Access Compliance Report

Public Rights-of-Way

| Intersection ID: 3937 | Main Street: CULLINGFORD_LN | Cross Street: ROYCE_HALL_LN | Location: SE |
| ADA ID: 9D1EBCDF4273 | Ramp Type: Perp | Initial Pass/Fail: Fail | Overall Compliance: No |

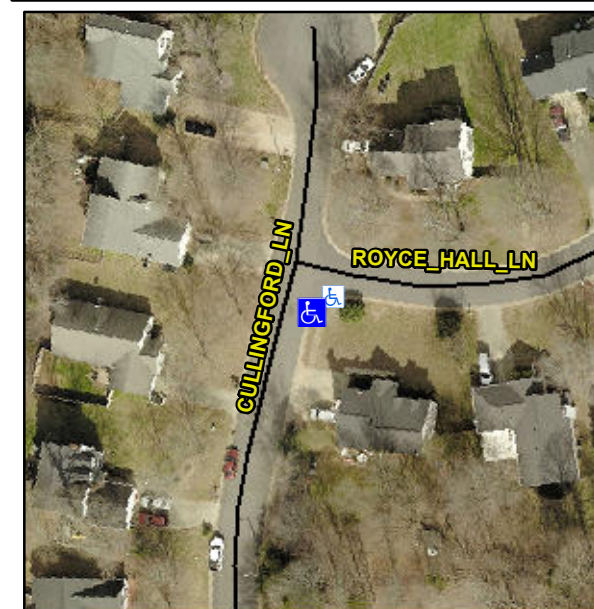
Not Found, R304.5.1, R304.2.2, R304.5.3

| Compliance | Description | Data | Compliance | Description | Data |
|------------|-----------------------|------|------------|-----------------------------|------|
| N/A | Ramp Length (in) | 98.0 | No | Ramp Slope (%) | 9.0 |
| No | Ramp Width (in) | 39.0 | No | Ramp XSlope (%) | 6.8 |

Remove & Replace Entire Ramp.
